Access Compliance Report

Public Rights-of-Way

(Curb Ramps)

Intersection ID: 4758	Main Street: ARKLOW_RD	Cross Street: BEAKER_CT	Location:	E
ADA ID: DFE33CD7B80F	Ramp Type: Perp	Initial Pass/Fail: Fail	Overall Compliance: No	Severity Score: 26.25

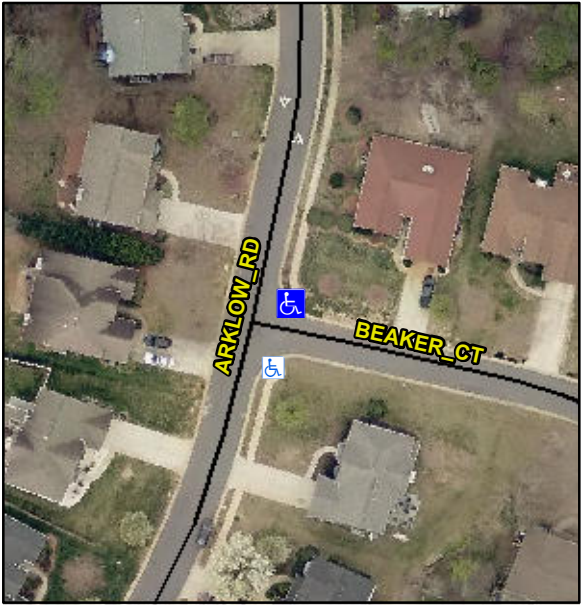
Codes/Mitigation Info/Possible Solution			Field Measurements/Component Compliance		
	Possible Solutions:		Compliance	Description	Data
	Remove & Replace Entire Ramp.		N/A	Ramp Length (in)	48.5
			Yes	Ramp Width (in)	54.0
			N/A	Flare Type LT	N/A
			N/A	Flare Slope LT (%)	N/A
			N/A	Flare Traversable LT?	N/A
			N/A	Landing Length (in)	N/A
			N/A	Landing Width (in)	N/A
			N/A	Landing Slope (%)	N/A
			N/A	Landing X Slope (%)	N/A
<p>Surveyor Notes:</p> <p>N/A</p> <p>PROW/ADA:</p> <p>Not Found, R304.2.2, R304.5.3</p>			N/A	Flare Type RT	N/A
			N/A	Flare Slope RT (%)	N/A
			N/A	Flare Traversable RT?	N/A
			N/A	DWS Provided?	N/A
			N/A	DWS Contrast?	N/A
			N/A	DWS Length (in)	N/A
			N/A	DWS Full Width?	N/A
			N/A	DWS Offset (in)	N/A
			N/A	Shared Landing?	N/A
			N/A	Gutter Ponding?	N/A
			N/A	Gutter Lip Ht (in)	N/A
			N/A	Painted X Walk1?	No
				X Walk 1 Direction	To SW
			N/A	X Walk 1 Width (in)	N/A
				X Walk 1 Slope (%)	9.4

X Walk 1 X Slope (%)	0.8
			N/A	Ramp inside XWalk1?	N/A
			N/A	Road Slope (%)	N/A
			N/A	Road X Slope (%)	N/A
			N/A	Any Obstructions?	N/A
				Obstruction Type	
Total Cost:		\$ 1850.00			
			N/A		N/A
			Yes	Surface Condition? (G/P)	Good
